ATTACHMENT NO. 8
Item No.: 17A-STC-01

NCUTCD Proposal for Changes to the Interim Approval IA-18 Intersection Bicycle Boxes

TECHNICAL COMMITTEE: Signals Technical & Bicycle Technical Committees
ITEM NUMBER: 17A-STC-01
TOPIC: Revisions to Interim Approval IA-18 Intersection Bicycle Boxes
ORIGIN OF REQUEST: Signals Technical & Bicycle Technical Committee
AFFECTED SECTIONS OF MUTCD: None. Interim Approval IA-18 only

Attachment IA-18-2 (Modified to reflect NCUTCD Recommendations)

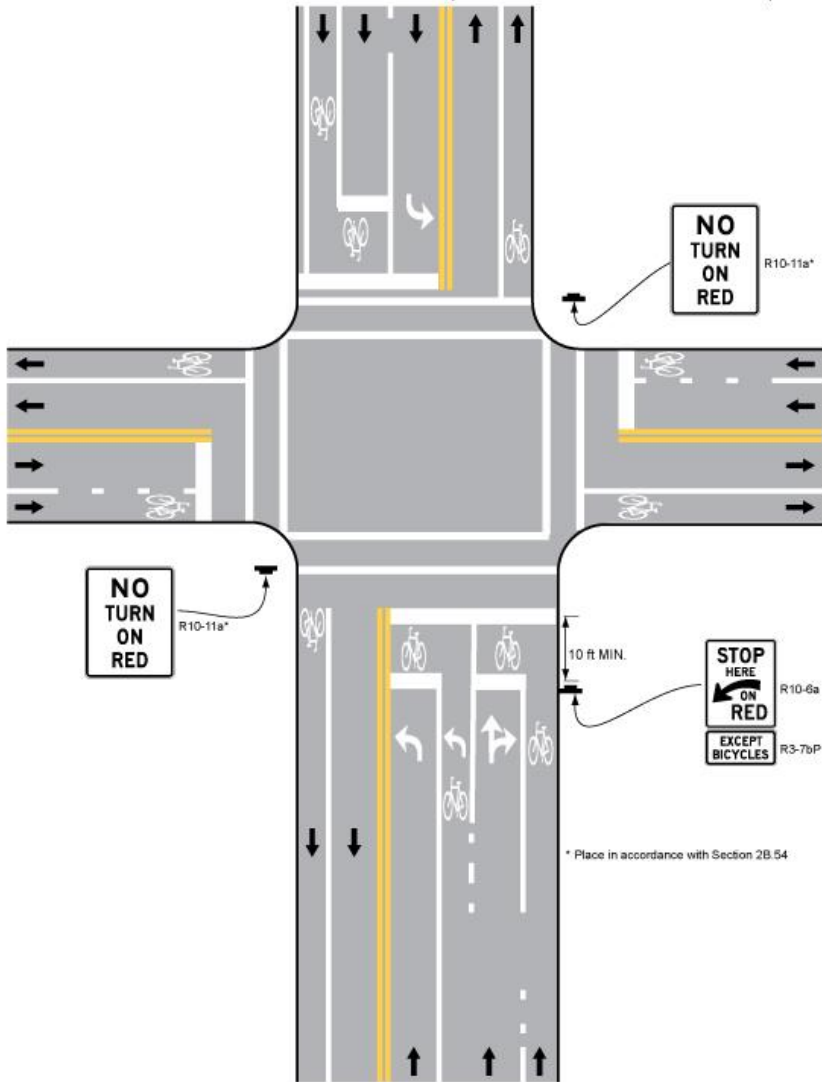
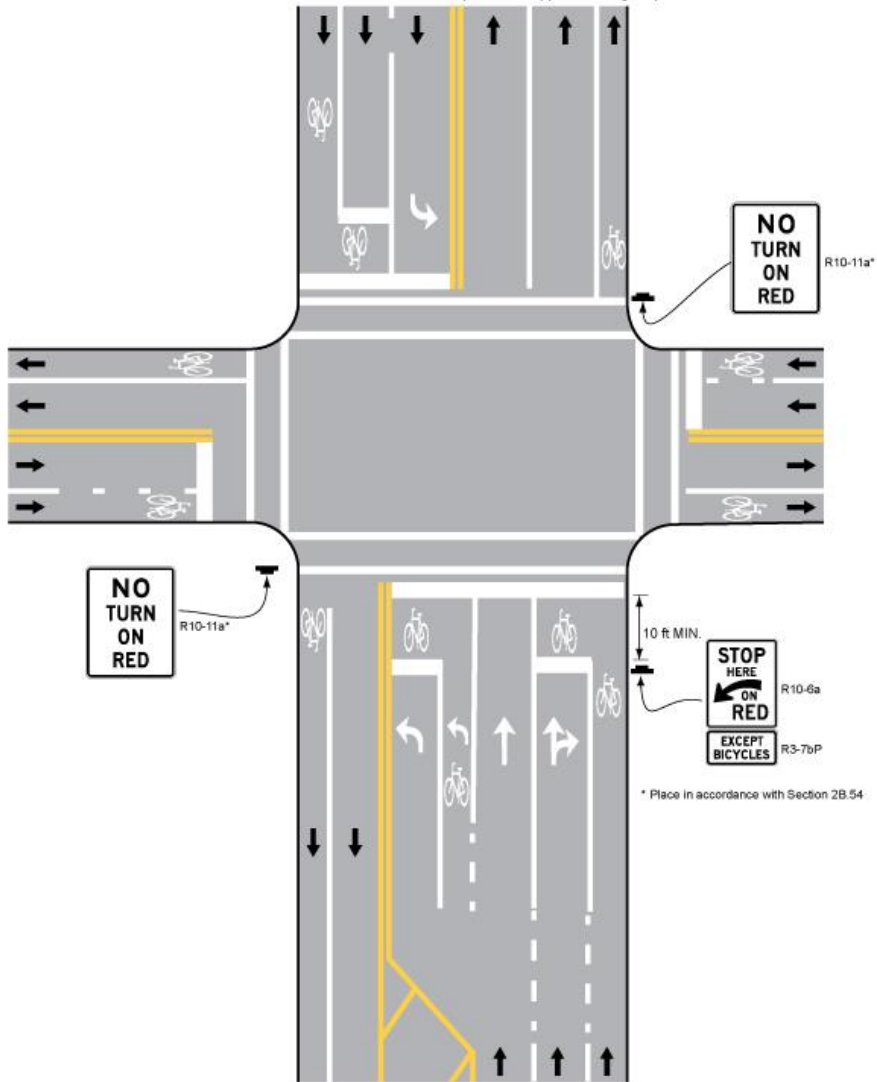
- 52
53
54
55
56
57
58
59
60
- 1. Revise IA-18 to delete reference to providing continuous multiple lane bicycle boxes (delete Provision 2c and Attachment Figure IA-18-2).
 - 2. Revise IA-18 to include a Figure illustrating a layout for separated non-continuous bicycle boxes across multiple lanes. Delete current Figure IA-18-2 and replace with new Figures as shown.
 - 3. The NCTUCD requests that the FHWA issue an Interim Approval for the NCUTCD-approved June 2016 Two Stage Turn Queuing Box.

R3-7bP
EXCEPT BICYCLES (PLAQUE)

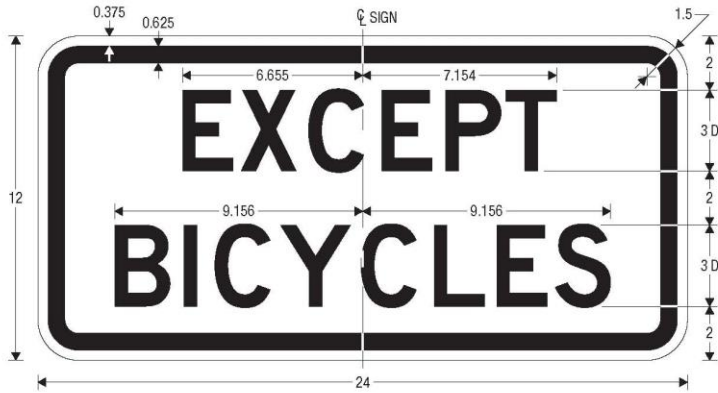
- 95
- 96 e. A STOP HERE ON RED (R10-6 or R10-6a) sign should be provided at the advance stop
97 line defining the bicycle box with an EXCEPT BICYCLES (R3-7bP) word legend plaque
98 below (see Attachments IA-18-1 and IA-18-2).
